VEHICLE RECALL

IC CORPORATION RECALL # 03306
NHTSA RECALL # 04V-010

SUBJECT: VEHICLE RECALL

Modesty Panel at Front Barriers

Area where
panel may be
bent out of
position.

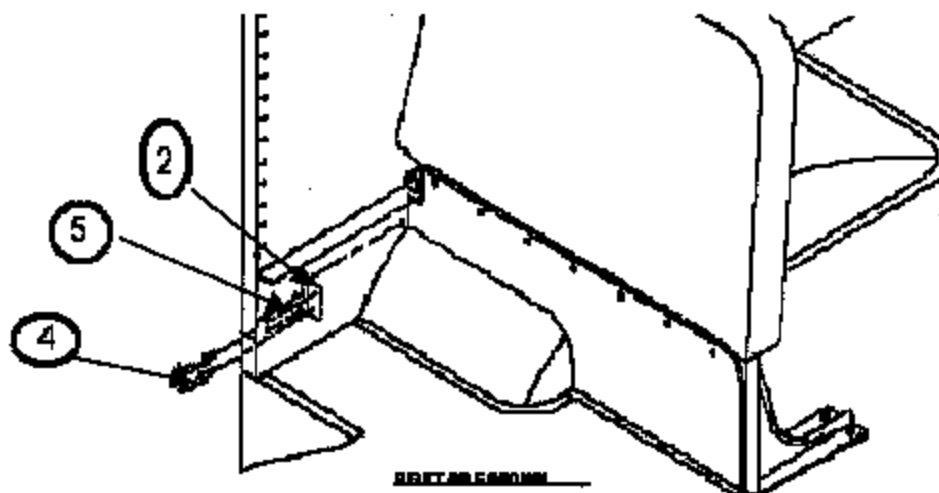
The steel modesty panel that is installed under the seat barrier behind the driver seat and behind the entrance door is cutout to clear the wheel well. This cutout allows the lower portion of the panel to be bent out of position leaving a gap between the wheel-well and the lower edge of the modesty panel at the cutout area. The edge of the cut out is protected with snake rubber (protective edging). If the snake rubber is knocked off of the edge of the panel, a raw edge is exposed facing down.

This repair procedure involves adding a bracket at the wall to secure the end of the modesty panel. This must be done to the panel on both sides of the bus.

1. Locate the angle (item #2) centered vertically with the end of the panel.
2. Install angle onto wall with two self-drilling screws (item #5).
3. Using a 1/8-inch drill bit, drill two holes through the angle and modesty panel.
4. Fasten angle to modesty panel with two (2) of item #4 –(rivet, pop 1/8")
